Proposed Corrigendum No. 1 to A/54A, “Guide to the Use of the ATSC Digital Television Standard”

1. RATIONALE FOR CHANGE

Figure 8.1 Segment error probability, 8-VSB with 4 state trellis decoding, RS (207,187). The plotted values shown are approximate.

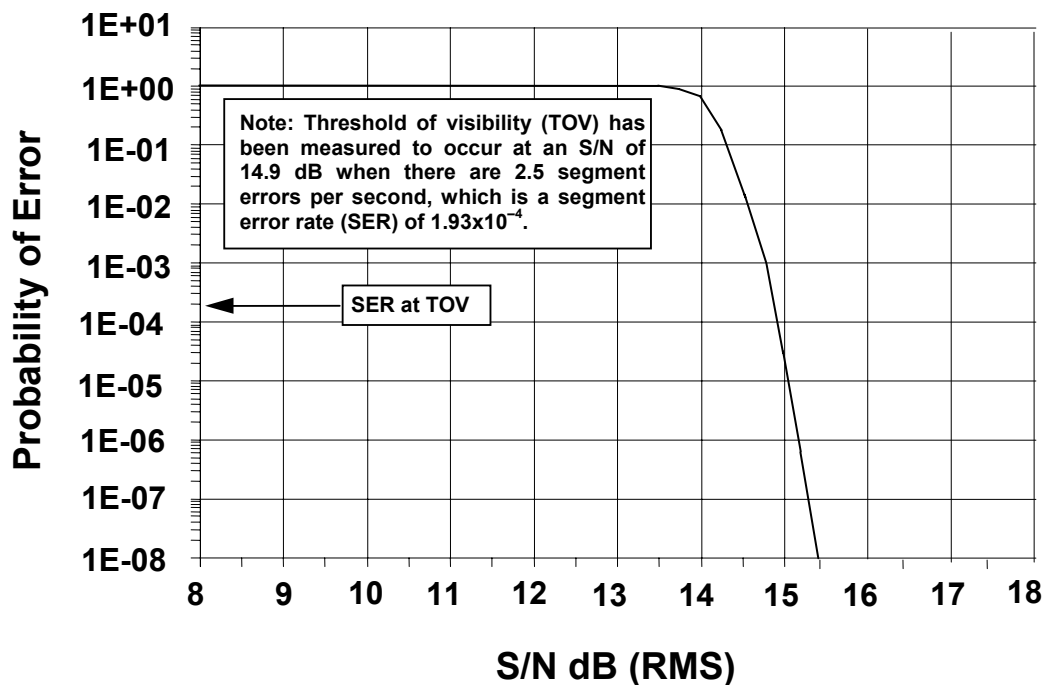
ATSC Recommended Practice A/54A, “Guide to the Use of the ATSC Digital Television Standard,” was published on 4 December 2003. It recently came to the attention of ATSC staff that the trace of Figure 8.1, “Segment error probability, 8-VSB with 4 state trellis decoding, RS (207,187),” is not correctly positioned relative to the horizontal axis. The replacement figure contained in this document corrects this error.

Replace Figure 8.1 of A/54A with the following illustration and outline.
